Access Compliance Report Public Rights-of-Way (Curb Ramps)

Main Street: PALOMAR_WAY Cross Street: FAIRHAVEN_AVE Location: SW

ADA ID: RPAT211022092859 Ramp Type: Type 6 - Directional 1 Initial Pass/Fail: Pass Overall Compliance: No Severity Score: 10

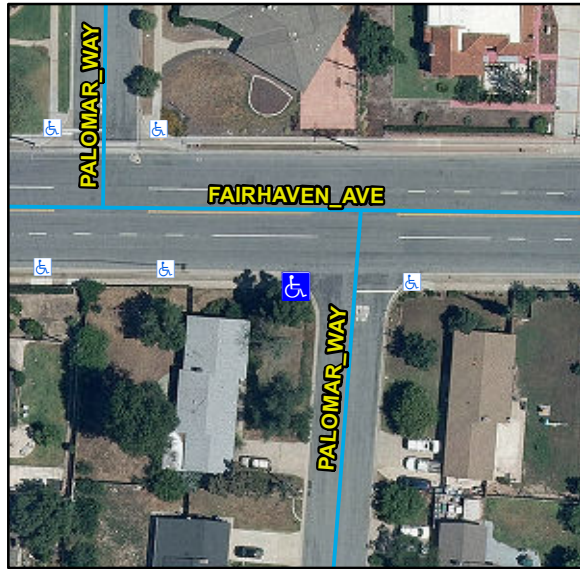
R304.2.1, R304.5.3, R304.5.4, STD 1115

Compliance	Description	Data	Compliance	Description	Data
N/A	Ramp Length (in)	160	Yes	Flare Type LT	
Yes	Ramp Width (in)	61			Curbed2
Yes	Ramp Run Slope (%)	6.8	N/A	Flare Slope LT (%)	N/A
Yes	Ramp Cross Slope (%)	1.5	N/A	Flare Traversable LT	N/A
Yes	Grade Break	Yes	N/A	Flare Type RT	
Yes	Grade Break Slope (%)	3.6			Sloped
No	Grade Break Cross Slope (%)	4.1	N/A	Flare Slope RT (%)	N/A
	Addl Para Ramp Left?	No	N/A	Flare Traversable RT	No
	Addl Para Ramp Right?	No	Yes	DWS Provided	Yes
N/A	Landing Present	Yes	Yes	DWS Contrast	Yes
No	Landing Length (in)	44	Yes	DWS Length (in)	77
Yes	Landing Width (in)	48	Yes	DWS Full Width	Yes
Yes	Landing Run Slope (%)	0.9		DWS Offset Type	Single
No	Landing Cross Slope (%)	2.9	Yes	DWS Left Offset (in)	0
N/A	Landing Movement Obstructed?	No	N/A	DWS Right Offset (in)	0
	Landing Movement Type	N/A			
N/A	Landing Shared	No			
N/A	Marked Crosswalk 1	No	N/A	Clear Space	Yes
	Crossing 1 Direction	SE	N/A	Clear Space To Crosswalk (in)	48

Marked Crosswalk 1 Width (in)	N/A			
N/A	Ramp Inside Crosswalk 1	N/A			
	Crossing 1 Slope (%)	4.3			
	Crossing 1 Cross Slope (%)	2.4			
Yes	Gutter Ponding	No	Yes	Curb Slope	5.4
Yes	Gutter Lip Height (in)	0		Road Run Slope (%)	0.7
No	Gutter Run Slope (%)	5.9		Road Cross Slope (%)	6.1
Yes	Gutter Cross Slope (%)	1.1		Parallel Ramp Side	N/A
Yes	Overall Surface Condition	Acceptable	Yes	Perp Joint Present	Yes
	Cross Gutter Present?	No		Spandrel Present?	No
	Replace Cross Gutter?	N/A		Replace Spandrel?	N/A

Remove & Replace Curb Ramp With Two New Directional Ramps or Equivalent. Remove & Replace Gutter.
